## MEMORANDUM

**RE:** 1165R Mass Ave Apartments – Traffic Peer Review Comment Responses  
Nitsch Project #13990

SHEET TITLE:  
**130 UNIT GARAGE VEHICLE TURNING EXHIBIT**

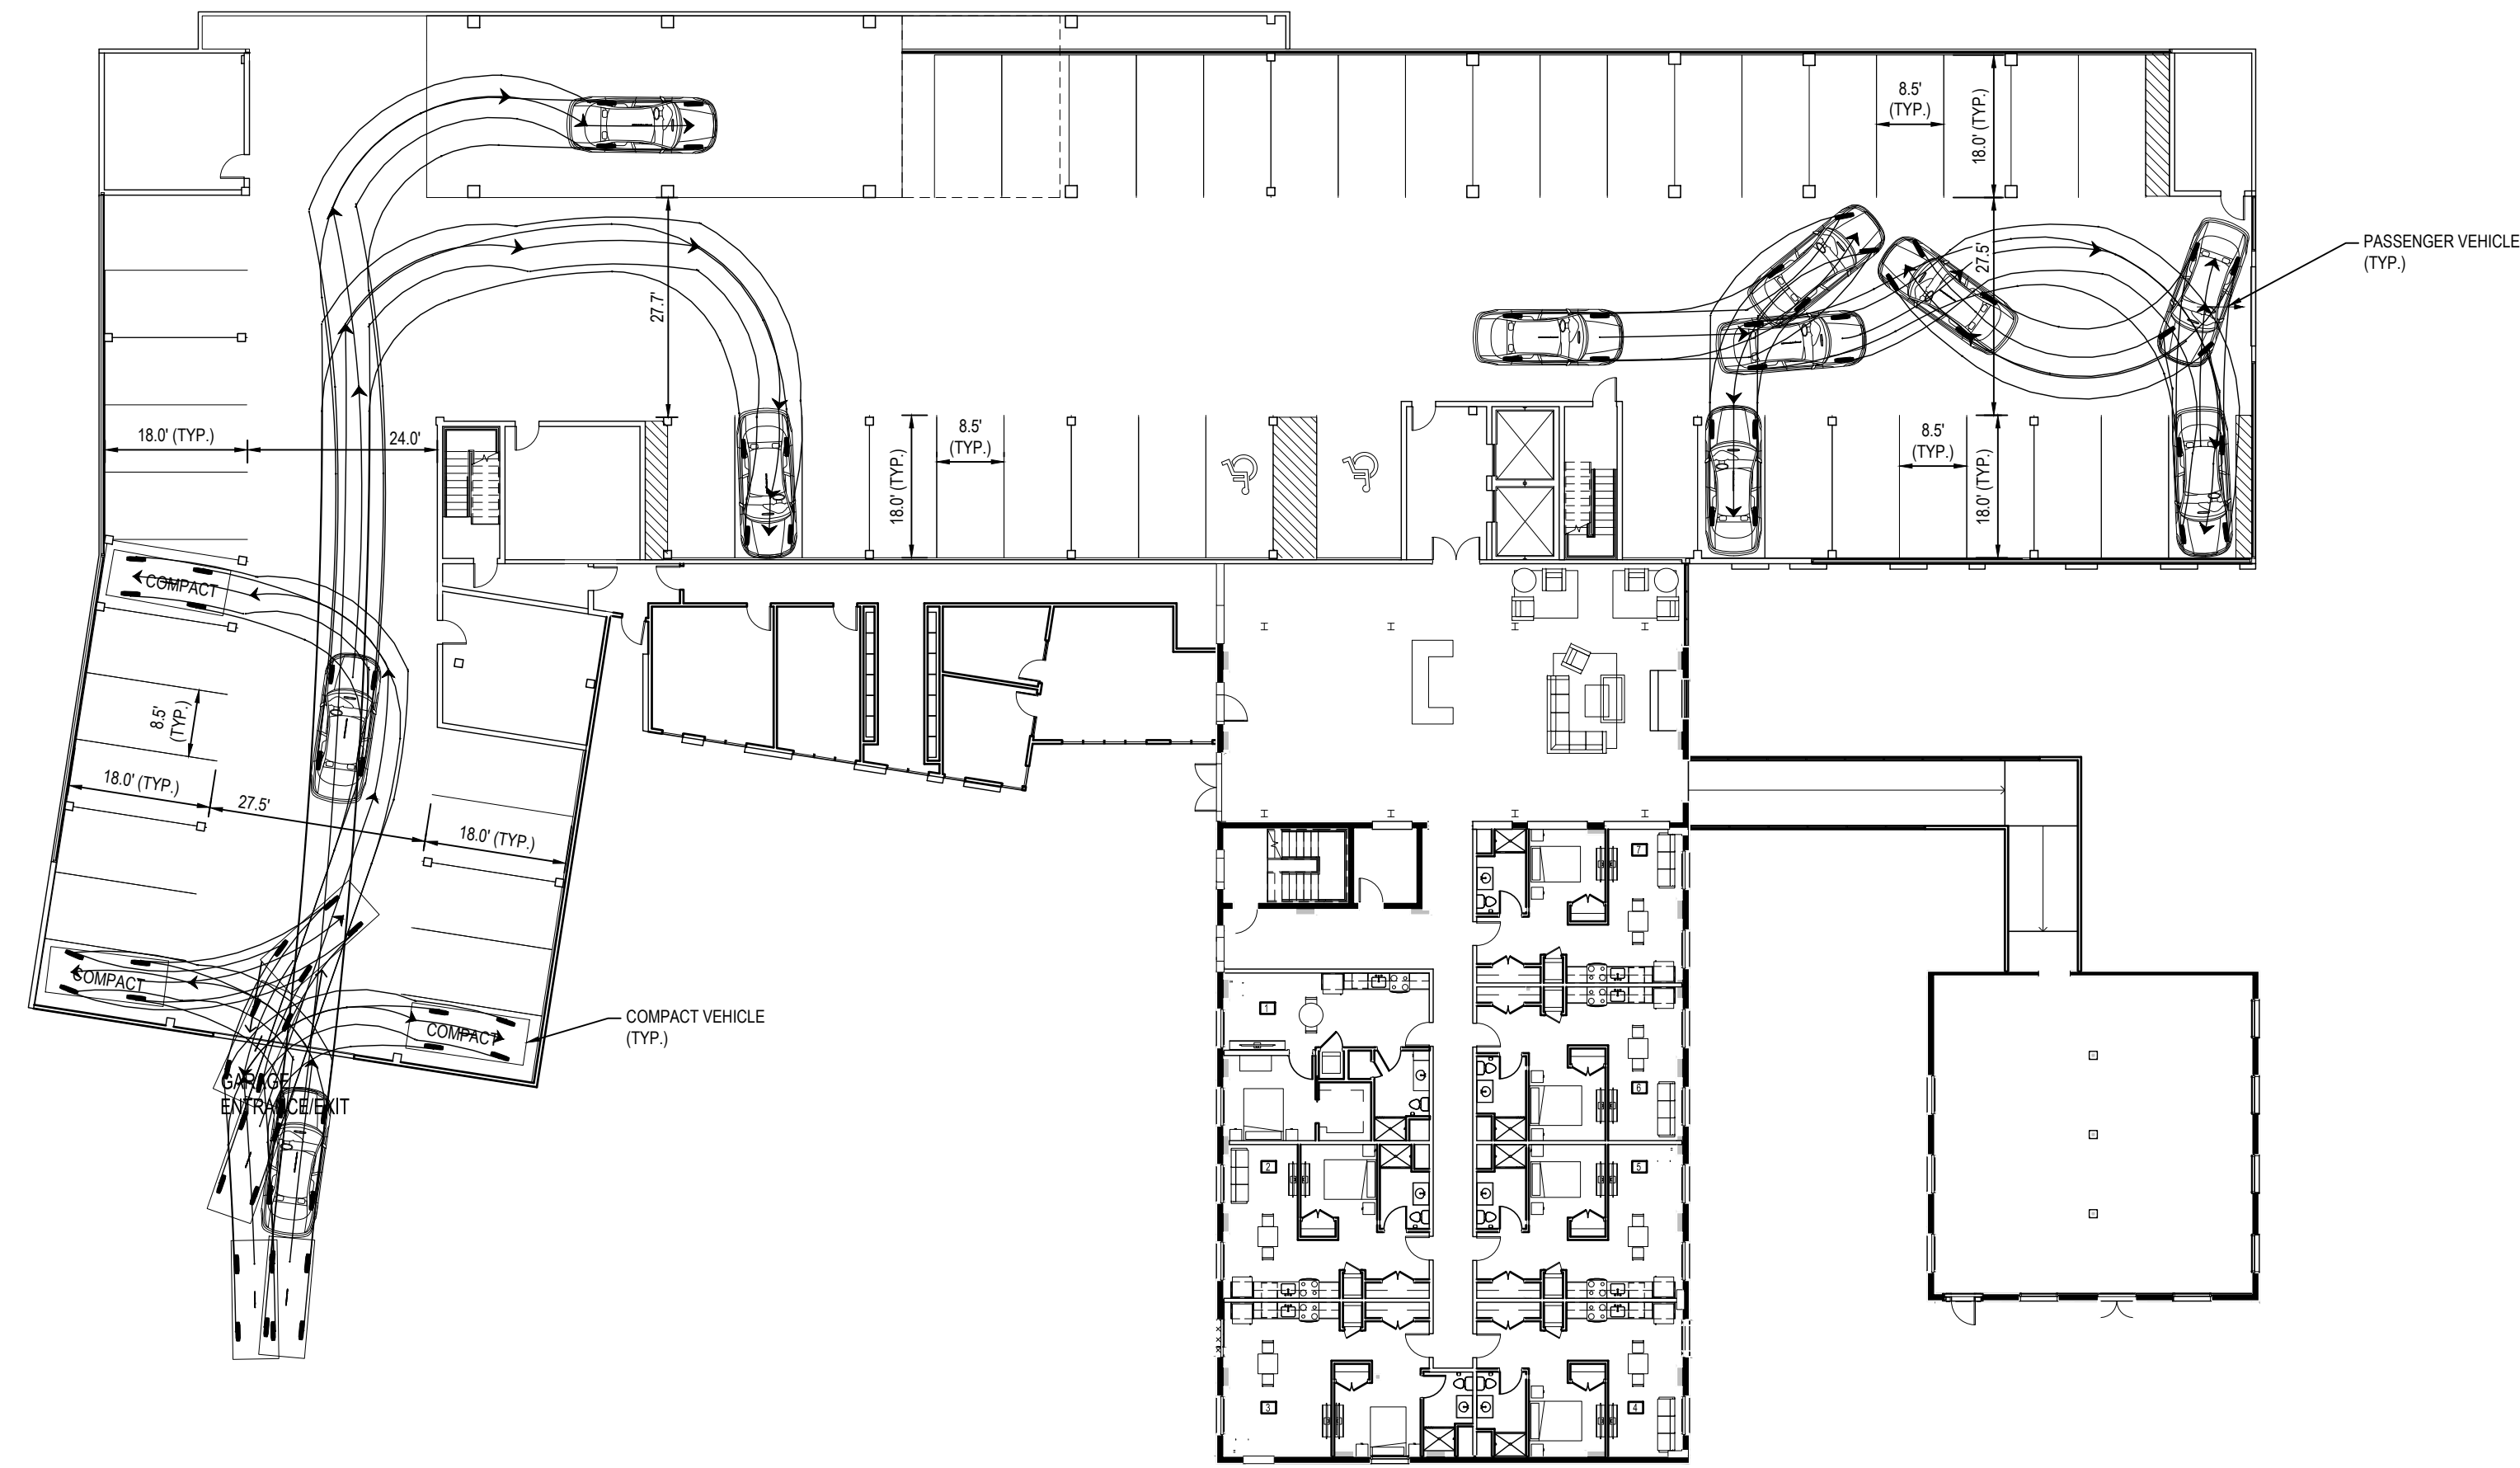
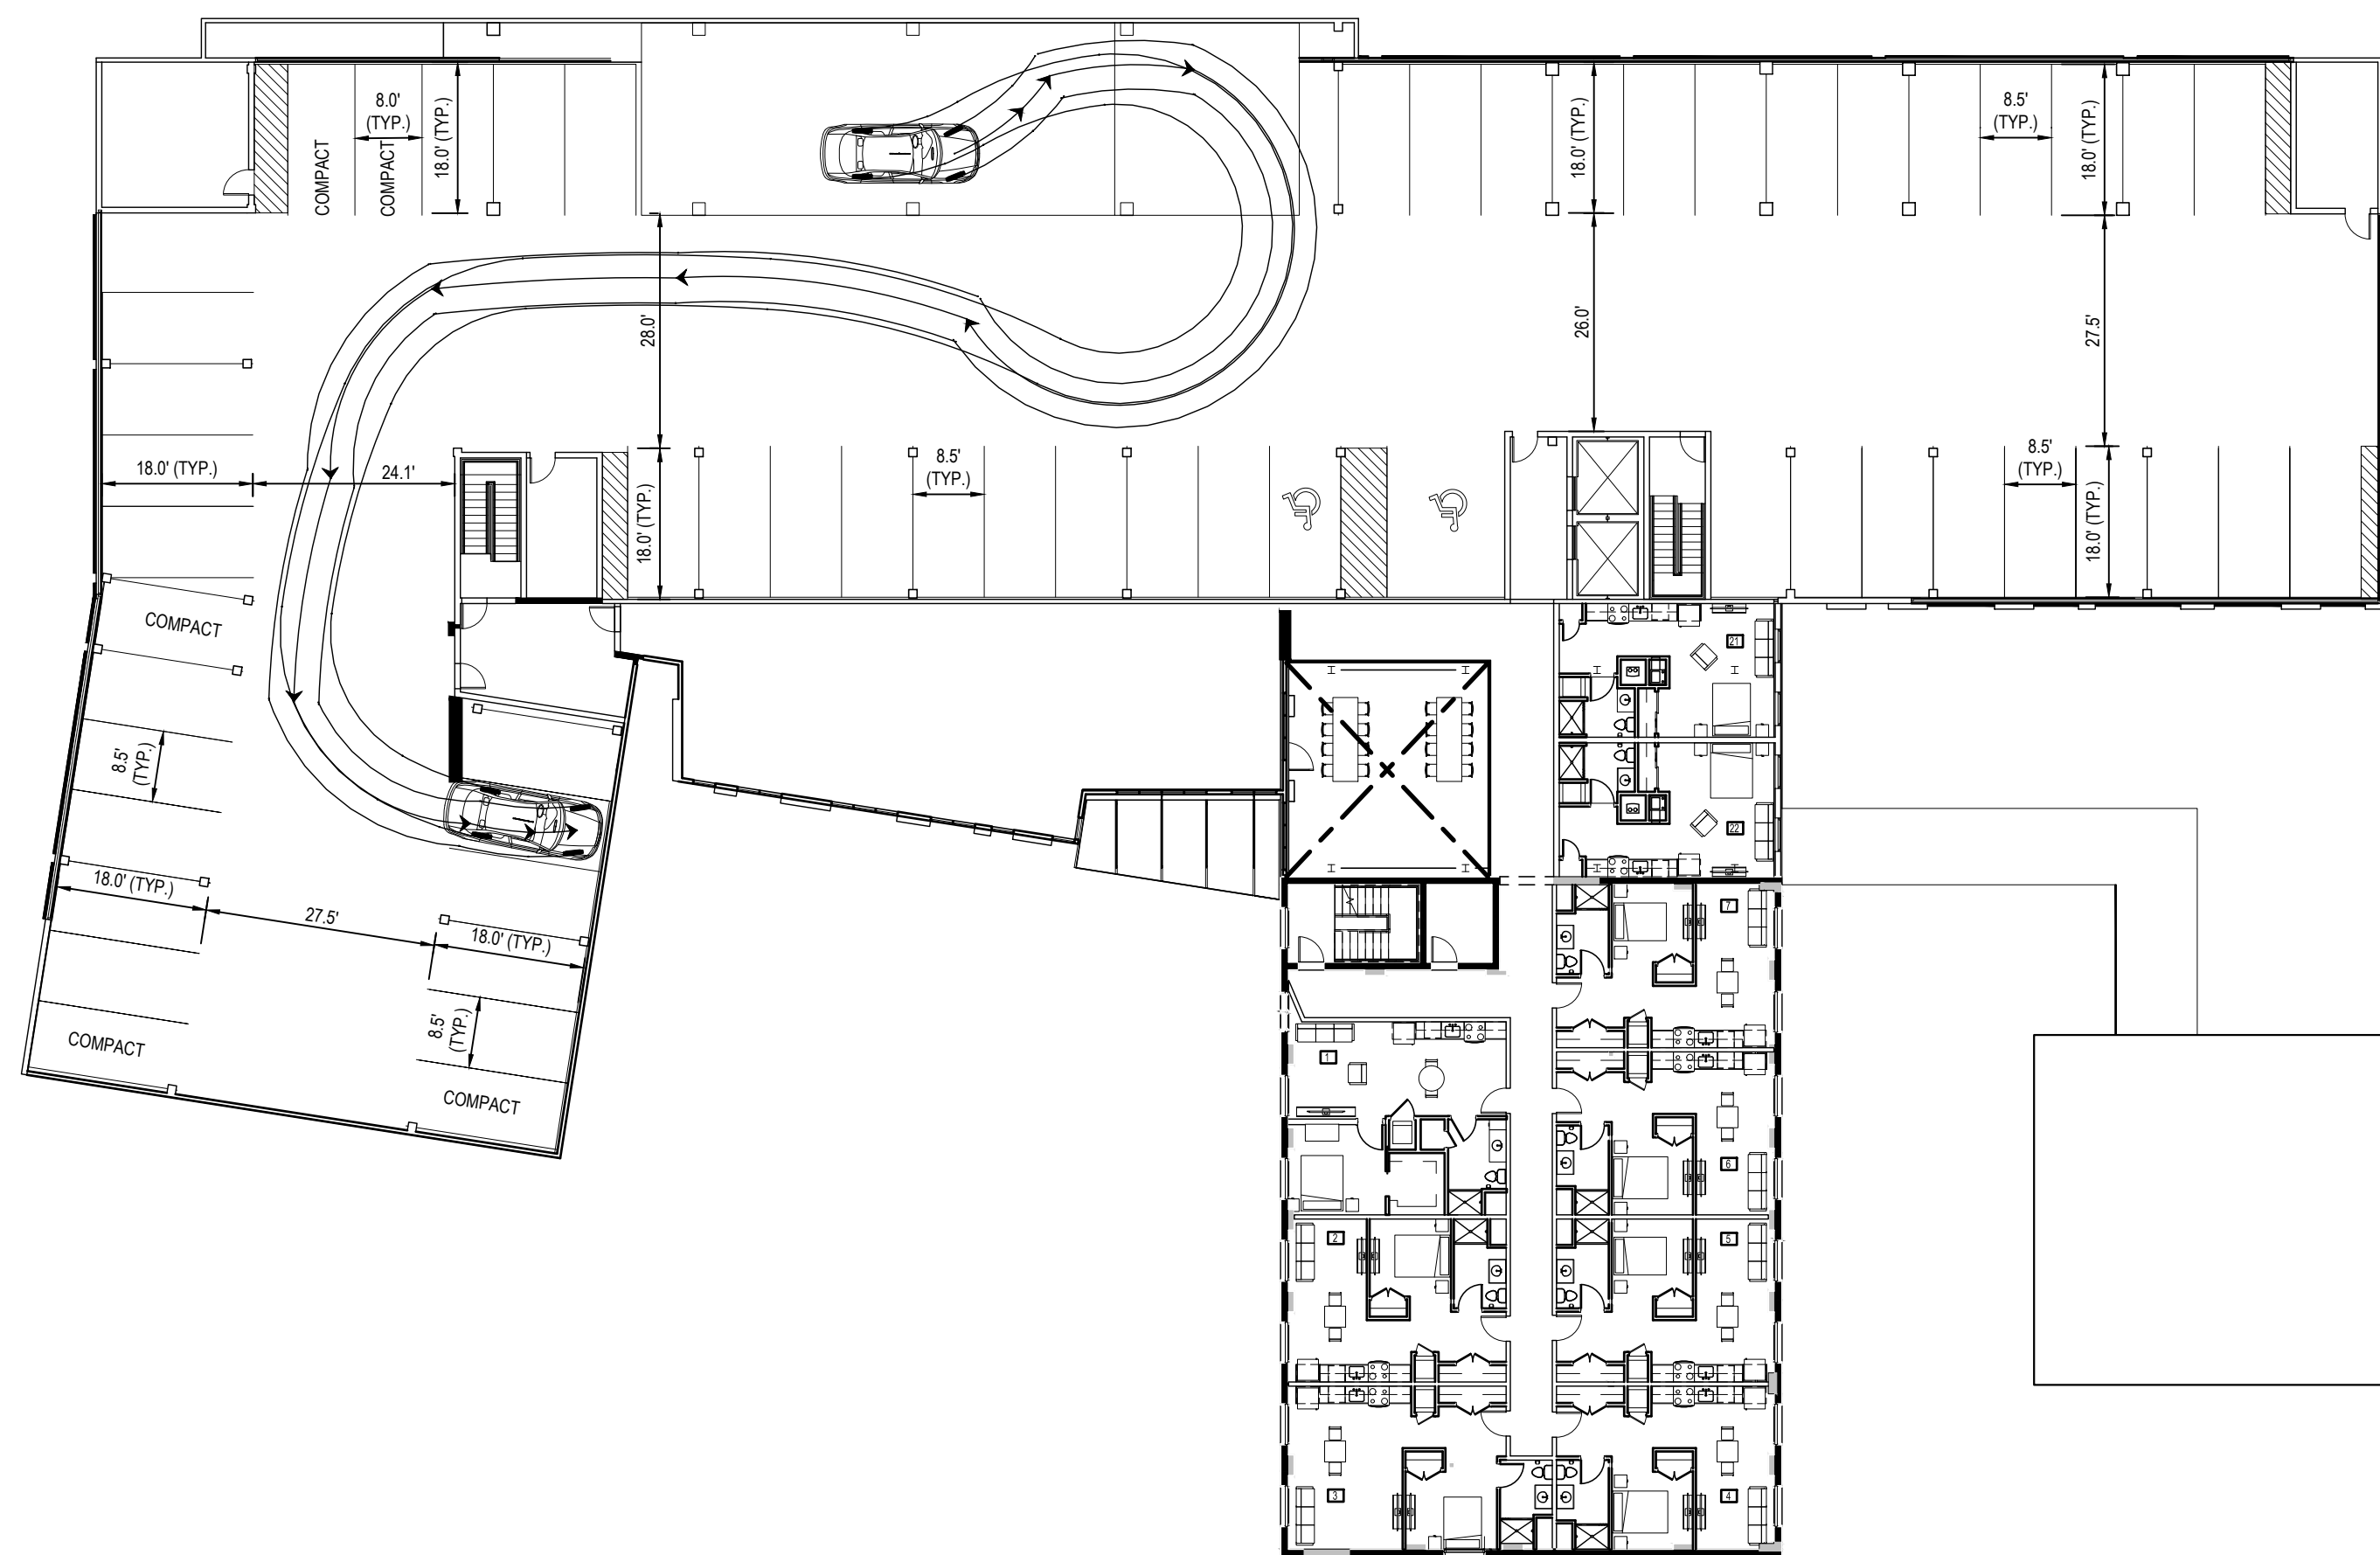
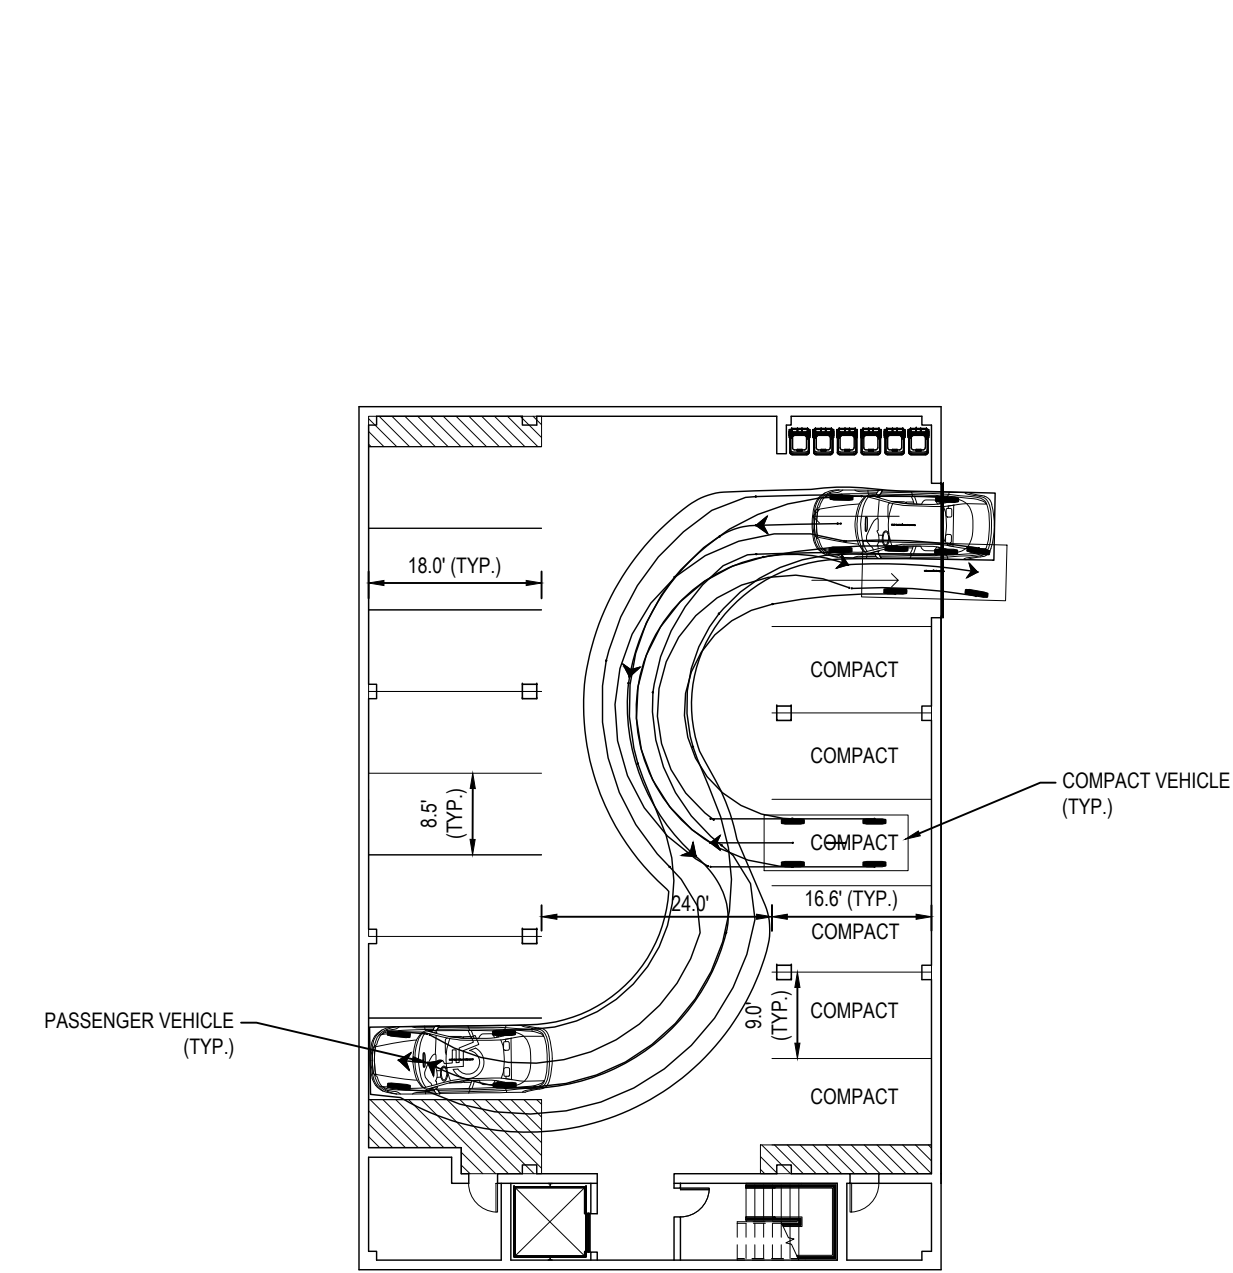
*T3a. The vehicle maneuver drawings suggest vehicles will strike support columns or walls, and will likely require vehicles to swing into adjacent parking spaces to adequately make a parking maneuver. A waiver to reduce aisle width is not recommended. Recommend maximizing the aisle width to accommodate multiple point turns to access parking without striking other vehicles, columns, or walls.*

*T4a. See Response T3. Turning maneuver drawings suggest vehicles will strike support columns or walls, and will likely require vehicles to swing into adjacent parking spaces to adequately make a parking maneuver. The tight garage will require multiple point turning maneuvers to safely access a space. This is more severe for spaces adjacent to end walls as shown on the turning sketches.*

*Building 2 is shown to have 1 accessible space adjacent to an elevator. This is acceptable, but will require an awkward move to exit the space which may not be possible/easy depending on the physical restrictions of the driver.*

**R3a. The revised Garage Vehicle Turning Exhibit dated April 29, 2021, has been attached to this comment response letter for review. Two parking spaces have been removed from the previous plan, and compact spaces have been designated to allow for unobstructed access into parking stalls. Additionally, Building Floor Plans, dated April 22, 2021, have been attached to this comment letter and show all aisle widths a minimum of 24 feet wide. As shown, the cars can accommodate multiple point turns to access parking without striking other vehicles, columns, or walls.**

**R9a. The Garage Vehicle Turning Exhibit and Building Floor Plans have been revised to be consistent with each other and to show the accessible designated parking spaces. The Garage Vehicle Turning exhibit also shows the vehicle turn into the accessible space in Building 2 next to the elevator.**
